Subject: Planning & Urban Design Comments

Application No.: 19 243515 NNY 15 SA
100, 110, 114 and 120 Broadway Avenue and 223-233 Redpath Avenue
PLAN 806 PT LOTS 10 & 11
Ward 15 - Don Valley West

Appendix 1: POPS and Park Street Loop

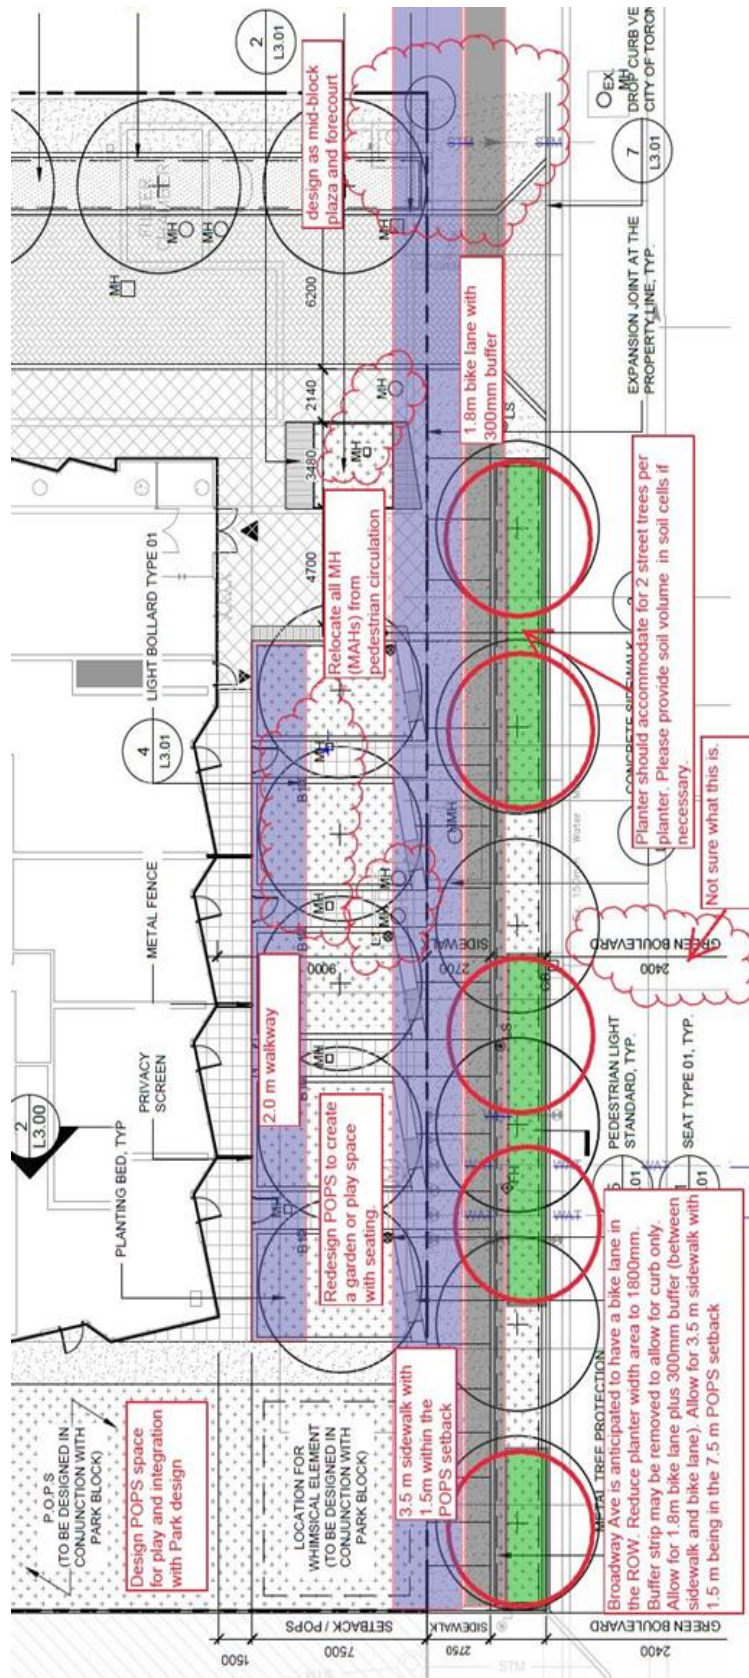
7. As per previous comments, staff are seeking to implement the Park Street Loop cross section along Broadway Avenue. Urban Design had provided a sketch of what this would look like for this application. Please see attached Urban Design sketch, and a general section of the Park Street Loop attached. It is not clear to staff why a bike lane has not been accounted for.
8. As per previous comments, provide an irrigation plan for the green roof. Although an irrigation plan has been provided, it does not appear to include the green roof.

12. As per previous comments, staff are seeking that infiltration trench drains are provided for the street trees, as per latest Toronto Urban Design Streetscape Manual details.
13. As per previous comments, staff are seeking to implement the Park Street Loop cross section along Broadway Avenue. Urban Design provided an applicable rendering in the last set of Planning comments. Please see attached. It is not clear to staff why a bike lane has not been accounted for.
